Site Specific Management Plan 007 - Waikanae River
MacKays to Peka Peka Expressway
M2PP-121-D-MPL-0007

SITE SPECIFIC MANAGEMENT PLAN - WAIKANAE RIVER AREA [SSMP 7 - SECTOR 470]

Appendix 2: CONSULTATION, FEEDBACK AND RESPONSES
Site Specific Management Plan 007 - Waikanae River
MacKays to Peka Peka Expressway
M2PP-121-D-MPL-0007

KCDC REVIEWERS COMMENTS: JW=Julia Williams- Landscape Architect; DP = Deyana Popova-Urban Designer; SK=Stu Kilmister-CWB Planner; SM= Shona Myers-ecologist – documented and meeting notes responses

3. PROPOSED SECTIONAL ELEVATION - WAIKANAE NORTH ABUTMENT - 1:200@A3

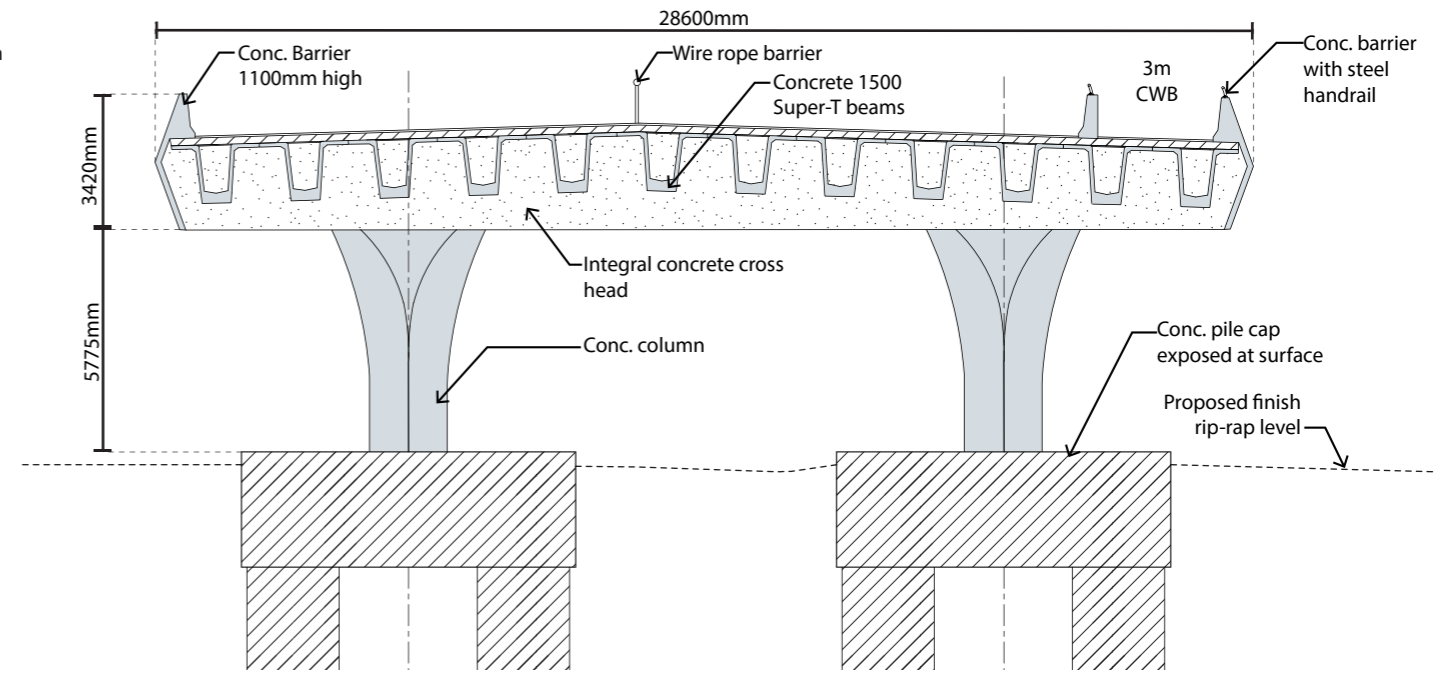
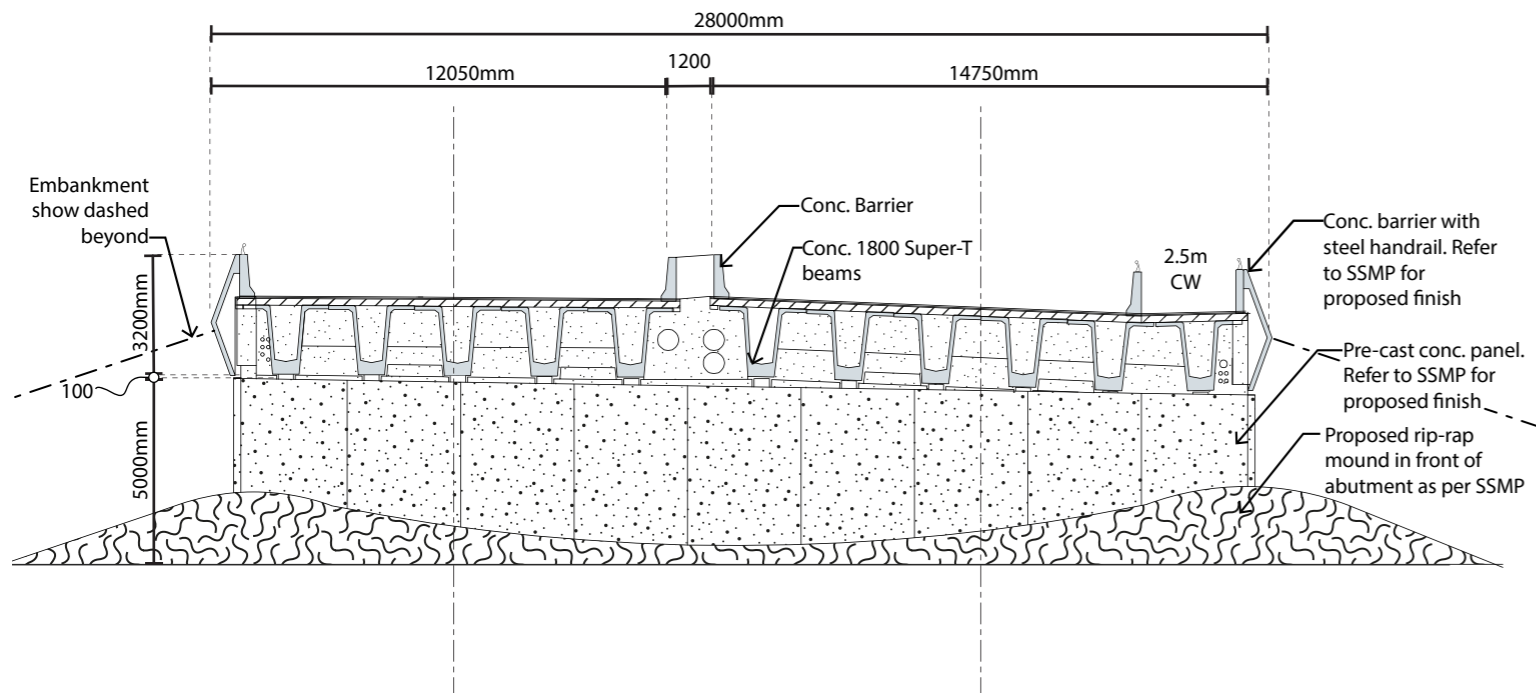
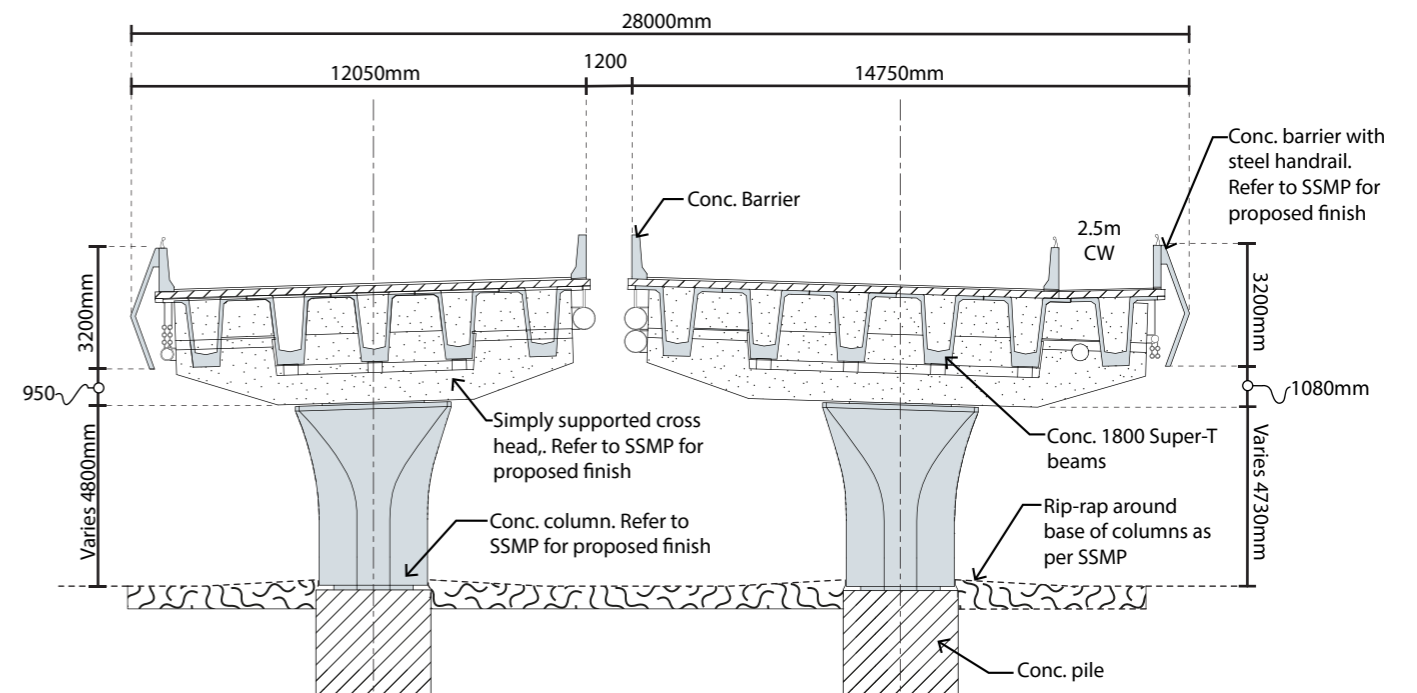
DC.7A, DC.57A & DC.59A	SSUDPs and SSLMPs must be consistent with the ULDF	JW/DP	UDLF 5.8.3 & 4: Inconsistencies. Greater level of detail is required to clarify the design in terms of quality and finish.		Changes to bridge forms as a result of detailed design process. Changes and rationale in relation to the ULDF set out in Appendix 3 Bridge Matrix
DC.57	The SSLMPs shall be consistent with the LMP	JW	LMP 8.54.2: Planting beside carriageway on southwest side of Expressway has native grasses as a transition at the edge. Clarify whether there is also an edge of gravel or grass directly adjacent to road – this is unclear on Sheet 16.	Sheet 16	Agree, this has been amended in the revised cross-sections to illustrate transition zone.
